PARK & RECREATION ADVISORY COMMITTEE MEETING
Monday, August 22, 2022 at 5:00 PM
Caledonia Village Hall – 5043 Chester Lane

Re: The Glen At Waters Edge Preliminary Plat – SW ¼ Section 16 & NW ¼ Section 21 Range 23 East Town 4 North Parcel ID's 51-104-04-23-16-021-000, 51-104-04-23-21-016-000, 51-104-04-23-21-016-010, & 51-104-04-23-21-021-000

PRELIMINARY PLAT OF THE GLEN AT WATERS EDGE

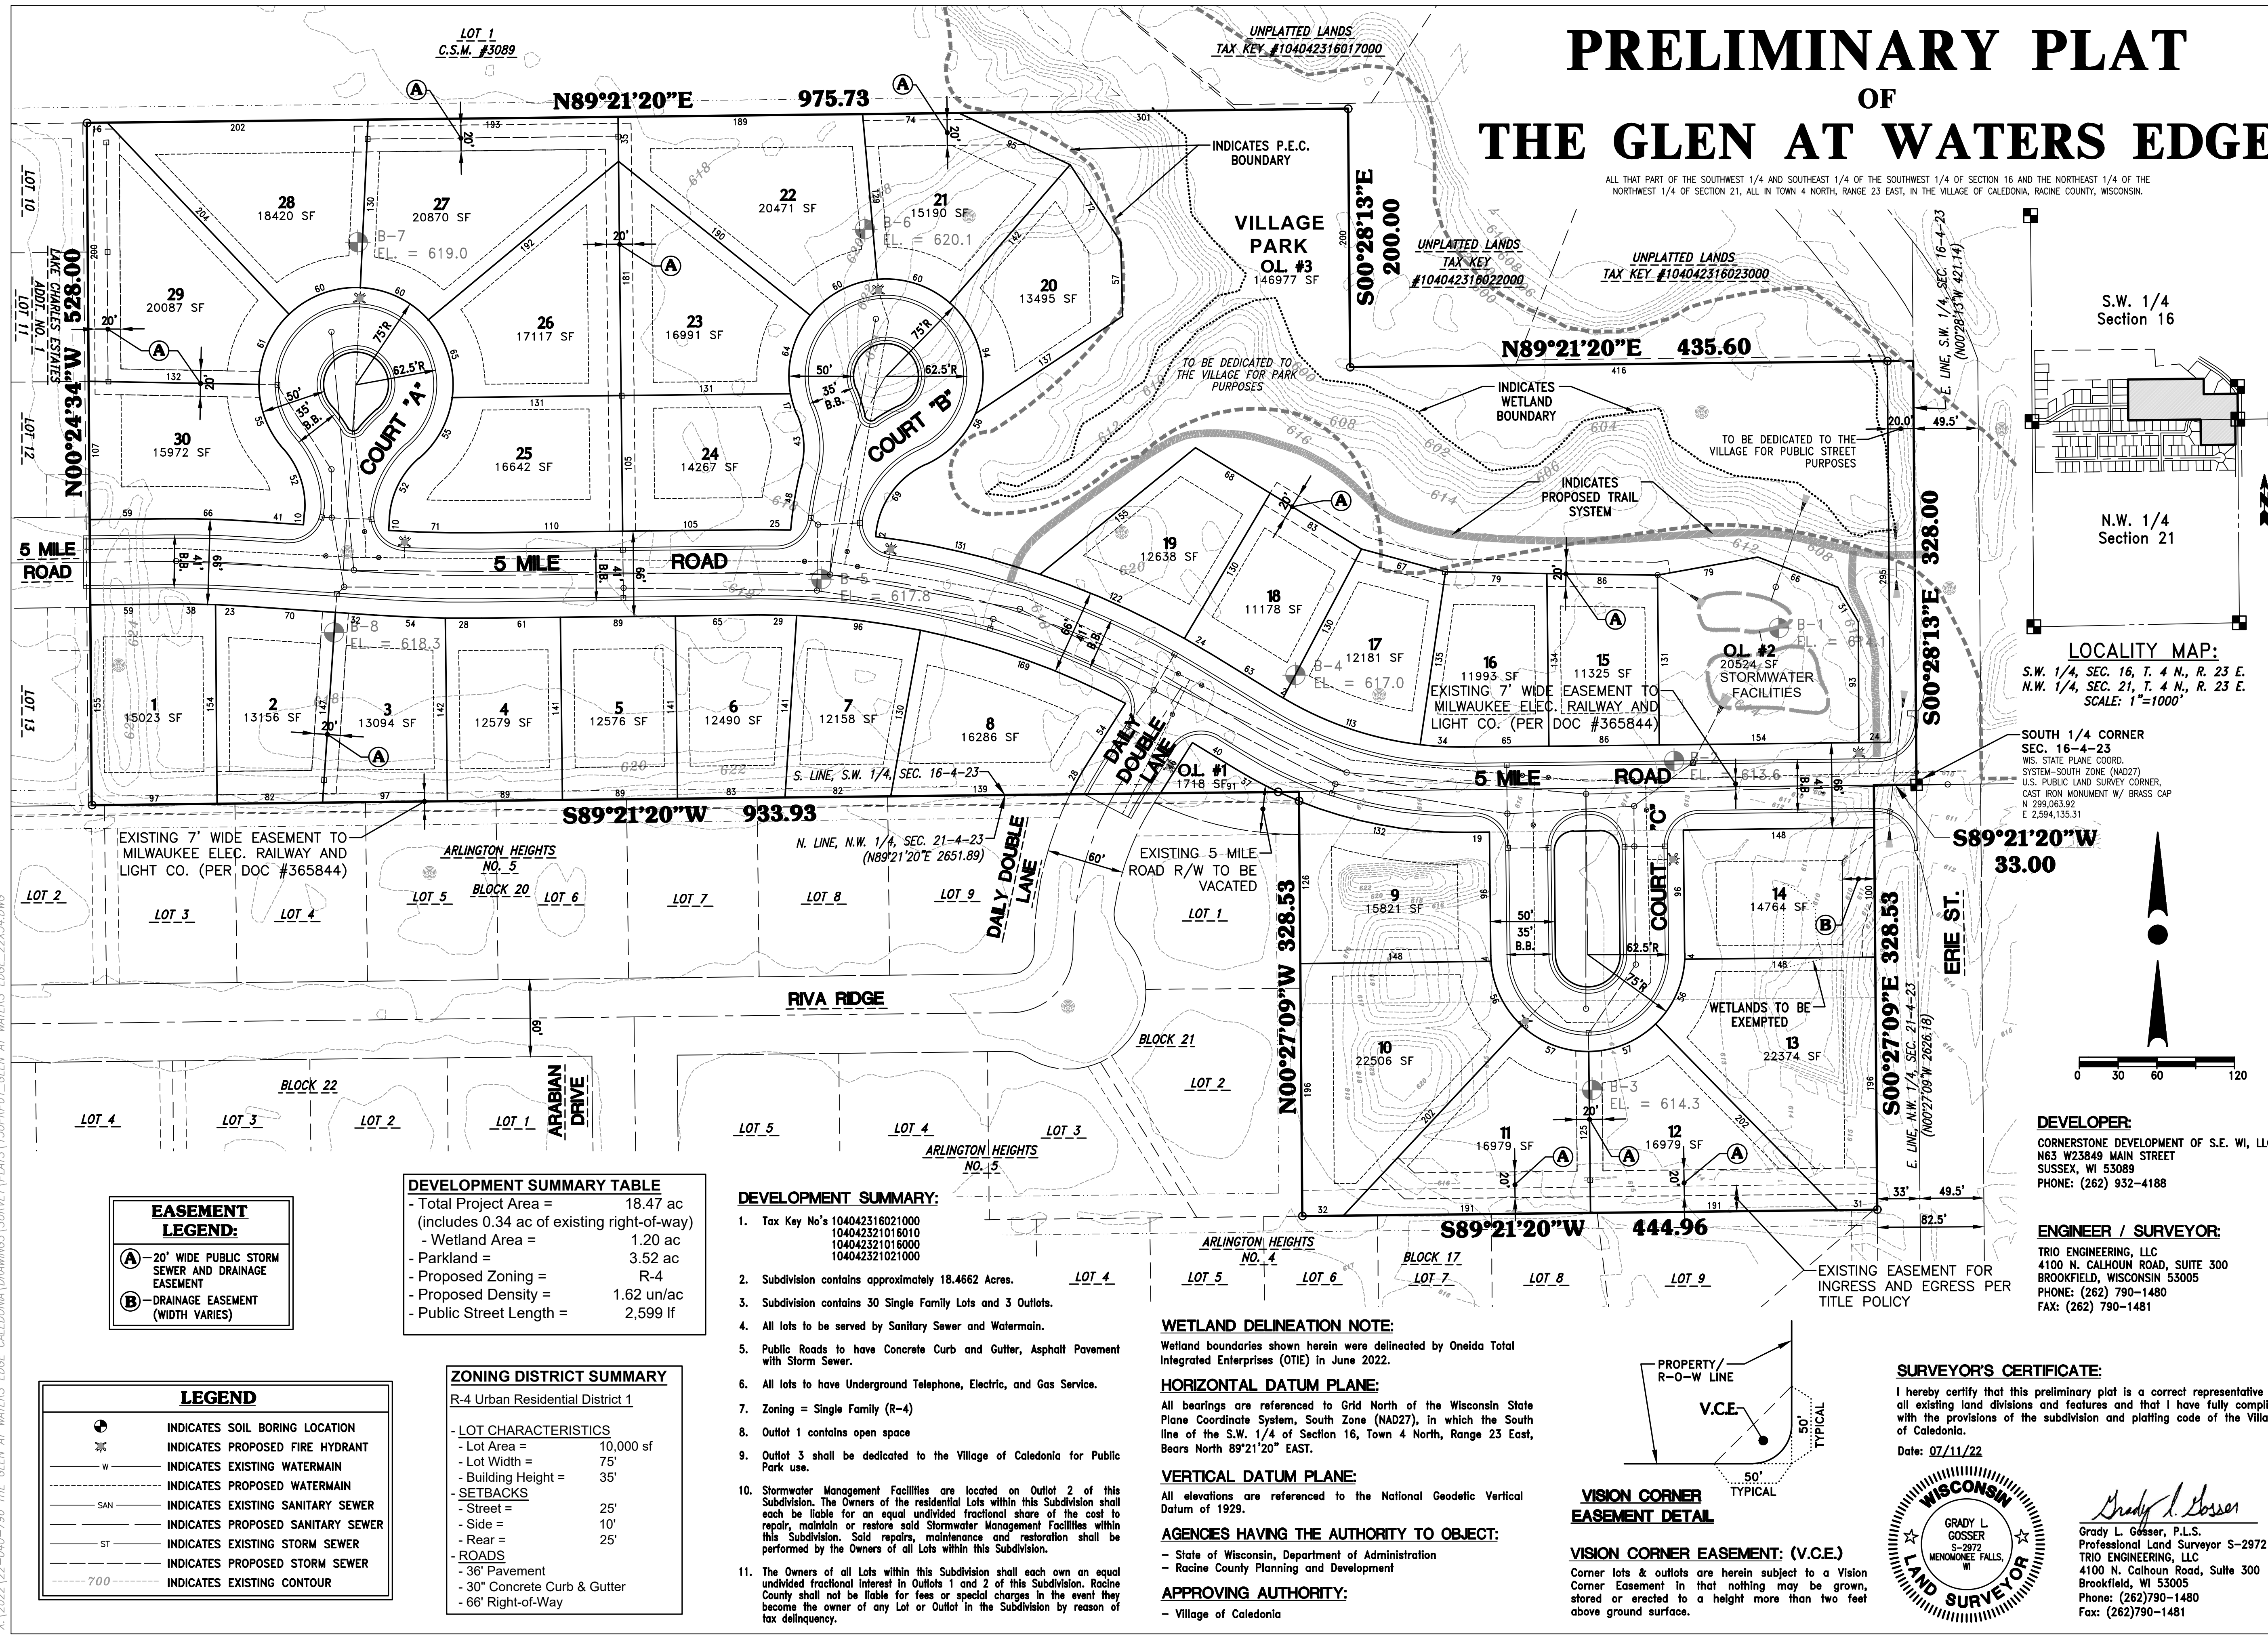
The Caledonia Land Use Plan indicates the parcels to be Medium Density Residential (6,200 square feet to 18,999 square feet). The Preliminary Plat for the subdivision has a range of lot sizes from 11,178 square feet to 22,506 square feet. The Preliminary Plat is consistent with the Village's Comprehensive Land Use Plan (2035 Land Use Plan). The 2035 Land Use Plan also indicates that there is Primary Environmental Corridor on the parcels. The Primary Environmental Corridor is shown, but will need to be confirmed as to the exact location by SEWRPC.

With the Preliminary Plat being located within the Sanitary Sewer and Water Service Areas the current Ordinance requires a minimum of 40% open space within the development. When performing calculations on the Preliminary Plat, it appears that the open space is approximately 26.66%. This will require a Modification Waiver from Ordinance 14-3-4(c)(4)(b)(ii). The Legislative and Licensing Committee had been working on a change in the Subdivision Ordinance that does not require open space for subdivisions within the Sewer Service Area that are served with both Sanitary Sewer and Water. They were also working on changing the Subdivision Ordinance so that Conservation Easements are not required within these subdivisions. This will also require a Modification Waiver from Ordinance 14-3-5(b). The Village Engineering Department supports the granting of the Modification Waivers as necessary.

5 Mile Road is considered a principal throughfare. Typically, a principal throughfare would require a 90' Right of Way. With an Urban Arterial Road Cross Section from the Ordinance, a 70' Right of Way would be sufficient. The 70' Right of Way would also match the Right of Way width on 5 Mile Road in Lake Charles Estates (subdivision immediately to the West). A 70' Right of Way for 5 Mile Road should be granted.

The 3 proposed cul de sacs are considered local roads. 66' of Right of Way would be appropriate for the straight sections of the cul de sacs. The proposed cul de sacs have 75' Radii for the Right of Way. The Radii of the cul de sacs shall be 80'.

Access for the parcels shall be limited to 1 access per single family lot. There shall be 50' No Access restrictions placed at the intersection of all corner lots (Lots 8, 9, 14, 24, 25, & 30). There shall be No Access Restrictions placed along 5 Mile Road on the lots with secondary frontage on 5 Mile Road (Lots 9, 14, 24, 25, & 30. Lot 8 shall be allowed access to 5 Mile Road due to insufficient frontage on Daily Double Lane.). There also shall be No Access Restrictions placed along Waters Edge (Lots 13 & 14).

In addition to No Access Restrictions there also will need to be 25' x 25' Vision Triangle Easements placed at the intersections of all corner lots (Lots 8, 9, 14, 24, 25, & 30). The detail provided will need to be adjusted as necessary and the easements will need to be shown on the lots.

The drainage of the lots within the Preliminary Plat according to the Master Drainage Plan, show 2 separate watersheds (M-14-2 & M-14-3). The Northern drainage basin predominately drains East to the Drainage Way located in Outlot 3, then to the road culvert under Waters Edge (M-14-2). The Southern drainage basin predominately drains East to Waters Edge then North to the same road culvert (M-14-3). A Storm Water Management Plan will need to be submitted, reviewed, and approved by the Caledonia Utility District. A preliminary Storm Water Management Plan has been submitted for review. This preliminary plan will be reviewed and comments provided to the Developer when completed. The Preliminary Plat has indicated that a Storm Water Management Pond will be installed in Outlot 2.

In looking at the Wisconsin DNR Surface Water Data Viewer, there are mapped wetlands shown along the drainage way in Outlot 3. The Surface Water Data Viewer also indicates hydric soils on the majority of the property. A Wetland Delineation has been done on this property by OTIE and confirmed by the DNR in June 2022. Wetlands are shown on the Preliminary Plat.

The Preliminary Plat will need to be revised to update the Right of Way as indicated above.

- The execution of a Pre-Development Agreement and Deposit of \$3,000.00.**
- Approval of Modification Waivers from Ordinance 14-3-4(c)(4)(b)(ii) and Ordinance 14-3-5(b).**
- Approval of the Rezoning Request from R-3 to R-4.**
- Correct the Road name from Erie Street to Waters Edge.**

- **Add Names for Cul De Sacs.**
- **Addition of the Owner of the Parcels. Include name, address, and telephone number.**
- **Addition of all platted Right of Ways within 300' of the Plat (Silent Sunday Court, North Pointe Drive & Waters Edge).**

- **Addition of all public and private easements within 300' of the Plat.**
- **Provide ownership information for lots within 100' of the Plat.**
- **Designate areas of slopes greater than 12%.**

- **Note if there are any Burial, Historical, or Cultural Resources on the property.**
- **A legal description of the parcels.**
- **Provide Density calculations for the Plat.**

- **Primary Environmental Corridor will need to be confirmed by SEWRPC.**
- **Wetland Buffers/Setbacks and uses are shown as necessary. Add Notes describing the maintenance (e.g., No Mow) of the Wetland Buffer. Also add Notes as necessary for what uses can be done in wetland buffers.**

- **Adjust Lot 17 to remove Primary Environmental Corridor from the Lot.**
- **The Right of Way width of 5 Mile Road shall be 70'.**
- **The Right of Way for the local streets shall be 66'. Radii for the cul de sacs shall be 80'.**

- **Adjust the road widths for 5 Mile Road and the 3 cul de sacs to the required widths by the Ordinance. (Urban Arterial Road & Urban Cul de sac)**
- **Addition of a Note for all parcels being limited to 1 access.**

- **50' No Access Restrictions placed on the lots at the intersections (Lots 8, 9, 14, 24, 25, & 30).**
- **No Access Restrictions placed along 5 Mile Road on lots with secondary frontage on 5 Mile Road (Lots 9, 14, 24, 25, & 30. Lot 8 shall be allowed access to 5 Mile Road due to insufficient frontage on Daily Double Lane.).**

- **No Access Restrictions placed on Waters Edge (Lots 13 & 14).**
- **25' x 25' Vision Triangle Easements placed on the lots at the intersections (Lots 8, 9, 14, 24, 25, & 30). Adjustment of the detail for Vision Corner Easement for distance and that there shall be nothing grown, stored, or erected to a height more than 6' above the ground surface.**

- **Addition of a note for Outlot 2 being used for Storm Water purposes and being a Storm Water Easement. In addition, this will require a separate Storm Water Easement to be recorded to cover liability, maintenance, and a maintenance schedule.**

- **The granting of a 12' Drainage & Utility Easement along the exterior boundary of the subdivision. This will not be required along Outlot 1 or Outlot 3.**

- **Will need to add Utility Easements to the Plat when Utility layouts have been completed.**
- **Add Note on the Plat for restricting trees, plantings, buildings, berms, fences, etc. in easement areas and Right of Ways.**

- **Add Note on the Plat that Driveways shall not have a centerline slope steeper than 6%.**
- **Add Note on the Plat that “Lots have been filled greater than 3 feet and may require additional courses in the foundations to reach suitable soil. Will need to provide a soil compaction certification for the areas of greater than 3 feet of fill.”**
